WOLF CREEK

GC 02-0011

Subject: Docket No. 50-482: Supplemental Information for the Relocation of Technical Specification Cycle Specific Parameters to the Core Operating Limits Report

ATTACHMENT I
TECHNICAL SPECIFICATION CORRECTION

Table 3.3.1-1 (page 5 of 6)
Reactor Trip System Instrumentation

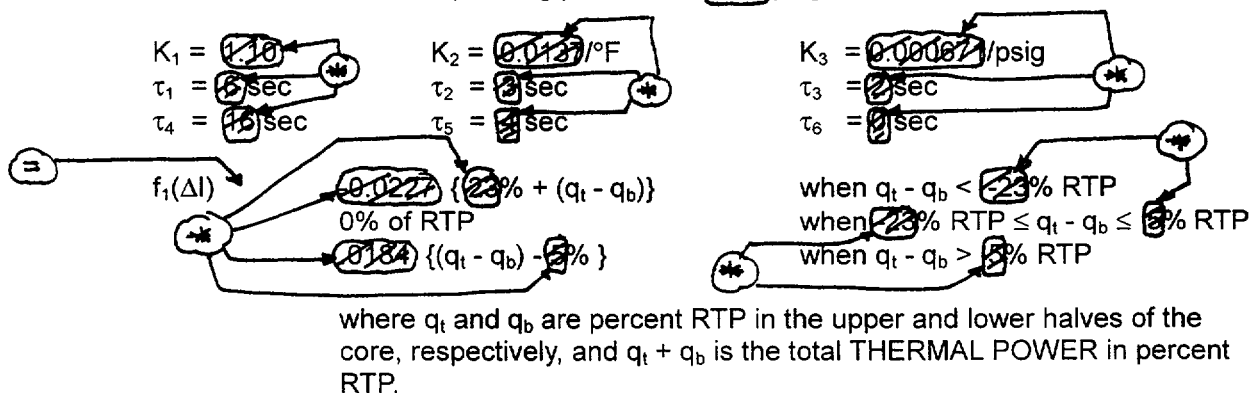
On February 28, 2002, Wolf Creek Nuclear Operating Corporation (WCNOC) personnel identified a potential error with the proposed change to the $f_1(\Delta I)$ equation in Technical Specification Table 3.3.1-1. The current $f_1(\Delta I)$ equation is specified, in part, as follows:

$$f_1(\Delta I) = -0.0227 \{ 23\% + (q_t - q_b) \} \quad \text{when } q_t - q_b < -23\% \text{ RTP}$$

Reference 1 proposed to change the "+" sign to a "-" sign. This change was based on a proposed method of defining the $f_1(\Delta I)$ breakpoints and slopes in the COLR. Upon further review it was identified that the change proposed to the $f_1(\Delta I)$ equation would result in an inconsistent application of the breakpoints and slopes.

The Attachment provides a revised markup of Technical Specification page 3.3-19. The correction to the proposed changes to the Technical Specifications do not impact the conclusions of the No Significant Hazards Consideration Determination provided in Reference 1.
